UNITED STATES PATENT AND TRADEMARK OFFICE

Office Action Summary

10/652,326

DETAILED ACTION

**FIG. 9**

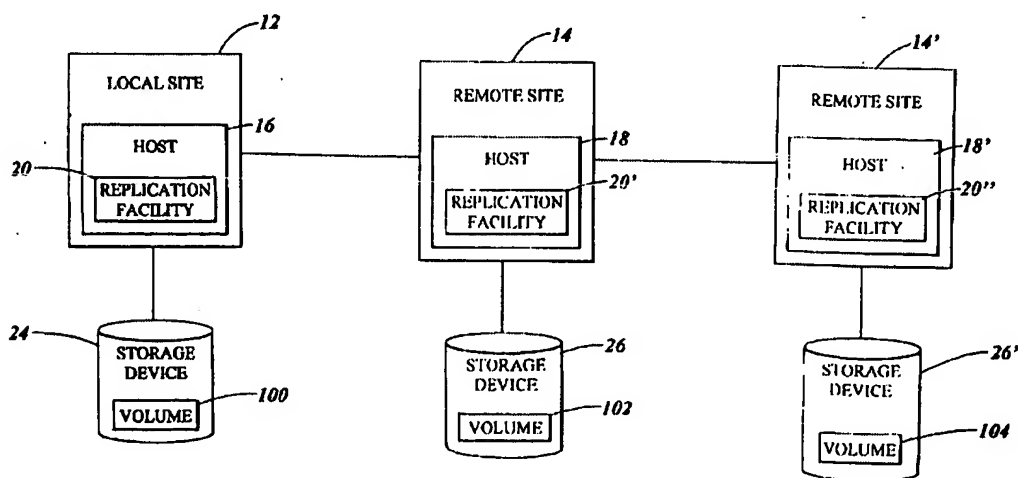
Regarding claim 3, applicant argued that Teloh does not teach asynchronous replication to the second node and asynchronous replication to the third node. On the contrary, Teloh teaches the claimed invention at Fig. 9, wherein each of the replication facility "supports **synchronous** data replication and **asynchronous** data replication" at [0042]. In one embodiment, Teloh teaches the replication of data from storage device 24 to 26 is **synchronous** and from 26 to 26' is **asynchronous** (page 2, [0018]). In another embodiment at [0058], Teloh replicates data from storage 24 to 26 **asynchronously**, and therefore anticipates the claimed invention.
